# ETROC2 questions and answers (FAQs) → questions from Andrew

Quan Sun and Ted Liu for the ETROC team

updated on June 13, 2022

## Updated Possible PCB ground scheme

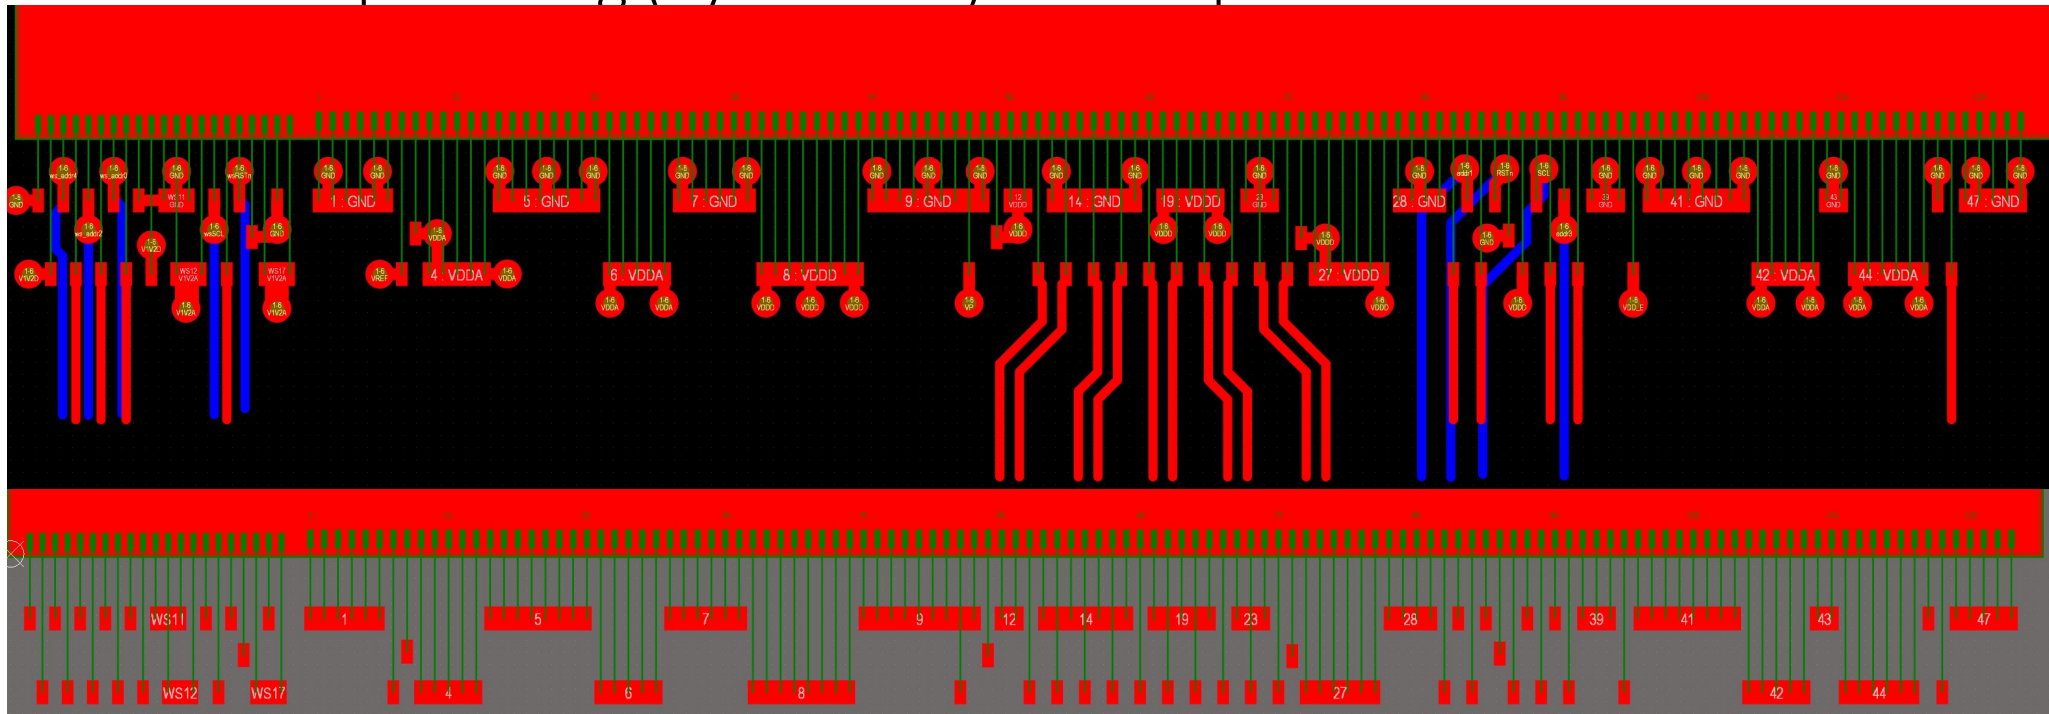
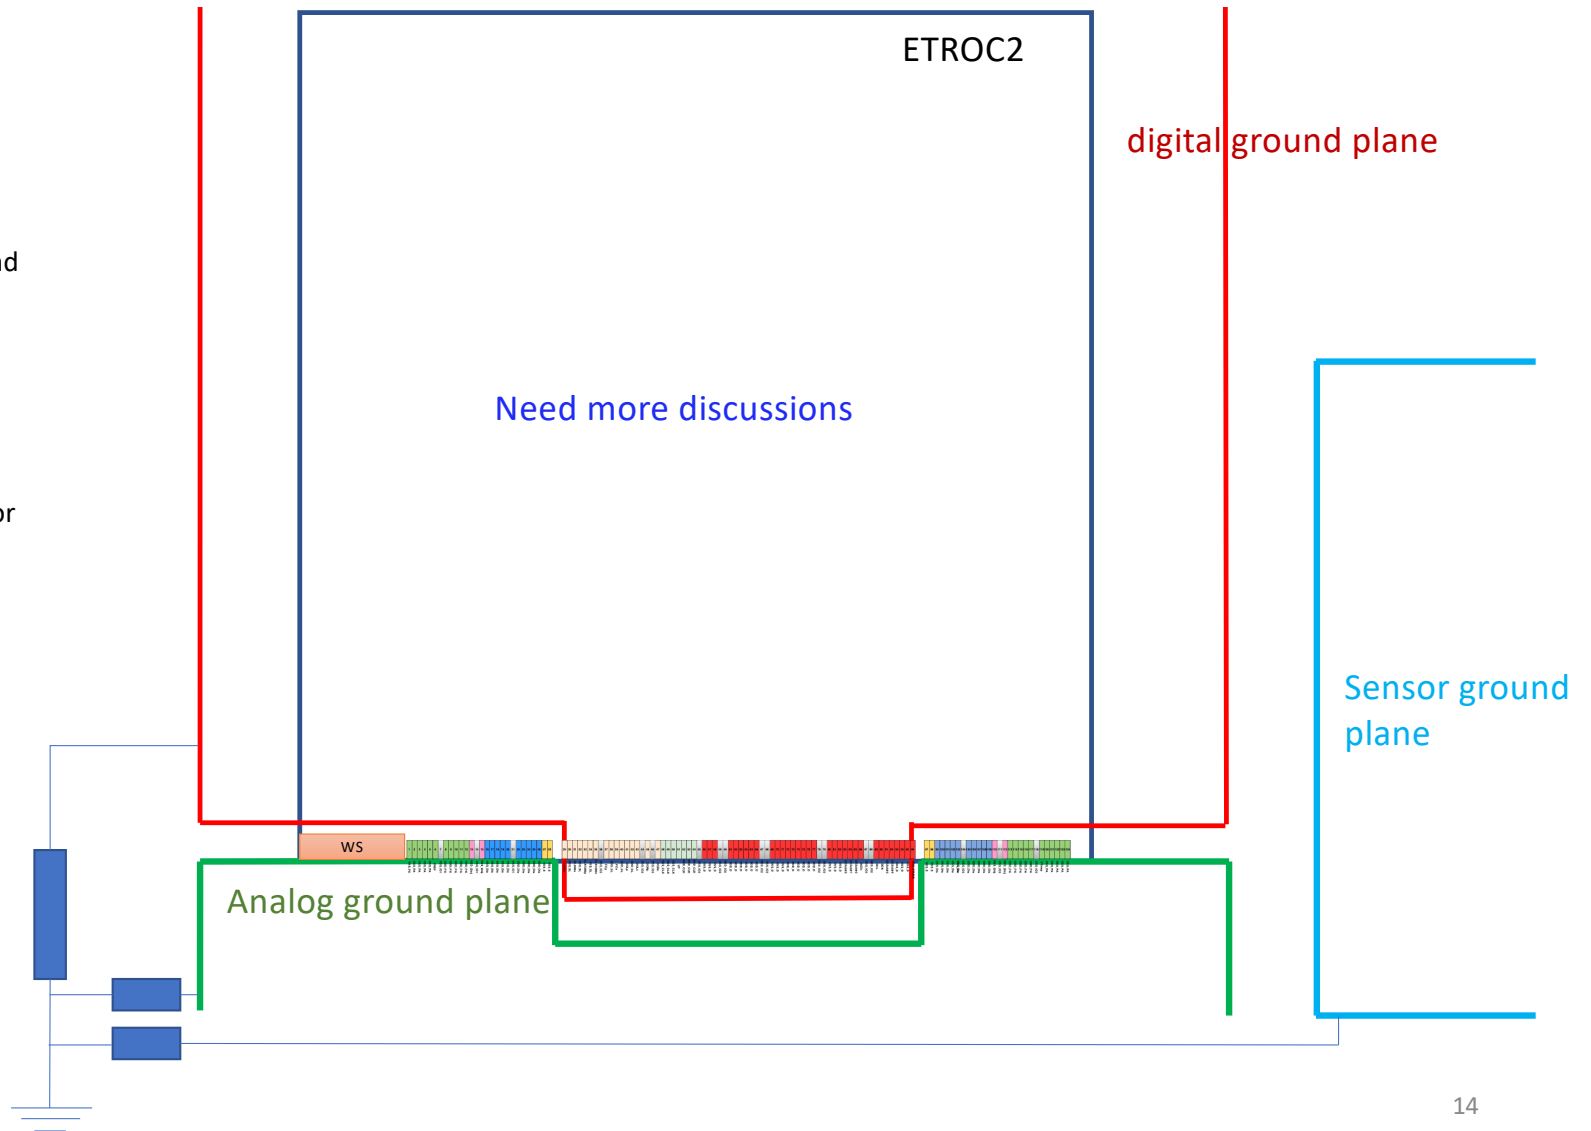
11. Since this presentation[1], do you have any update on a preferred ground scheme? (AGND/DGND vs. ASIC GND / HV GND)?

- Two nonoverlapping ground planes on the PCB
  - ASIC ground plane
  - Sensor ground plane
- Connecting two ground planes to a common ground with an inductor or a resistor (or multiple)

- Three nonoverlapping ground planes on the PCB
  - digital ground plane
  - Sensor ground plane
  - Analog ground plane
- Connecting three ground planes to a common ground with inductors or resistors (or multiple)

## Power Consumption

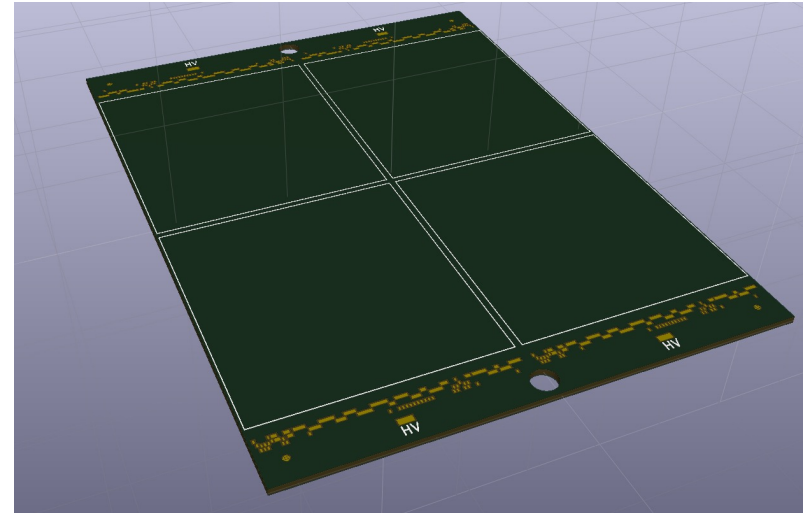
15. Do you have any approximate breakdown of the power consumed by the analog and digital domains separately? I have seen total power estimates but wondering how that breaks down, e.g. 0.25W analog 0.75W digital or whatever the real number is.

On ETROC2:  
 Delivering 2.56GHz clock to WS: ~20mW  
 (when not in use, this clock is disabled)

When WS disabled: ~ 8 mW

When WS is fully enabled (for short period, sub ms): 141mW. For module/readout board/power design, keep this in mind.

## Dimensions ETROC & Sensor as of 8 Feb 2022

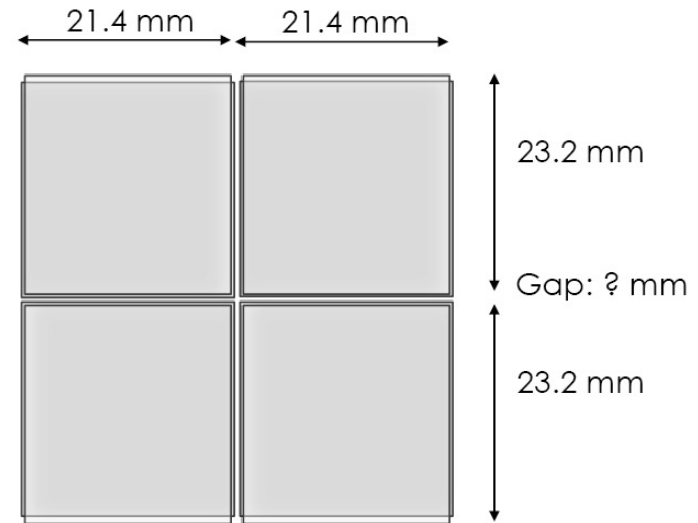
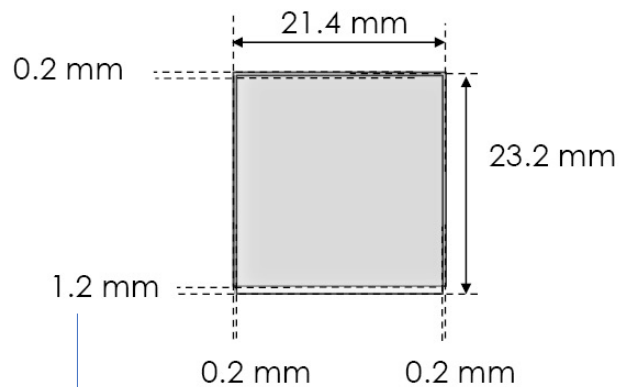
One minor thing to remind people:

This should be 1.6mm based on ETROC2 and sensor dimensions (checked with Nicolo)  
(this was noticed by Sergey Los recently during a discussion)
